ADA Curb Ramp New Construction Inspection Form (Perpendicular)

Nw 288 ter

24952.54

Nw carver st

PERPENDICULAR RAMP (PR)

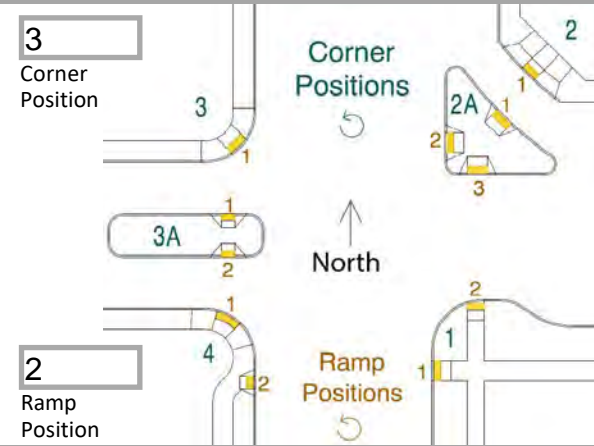
Too joints in turn space
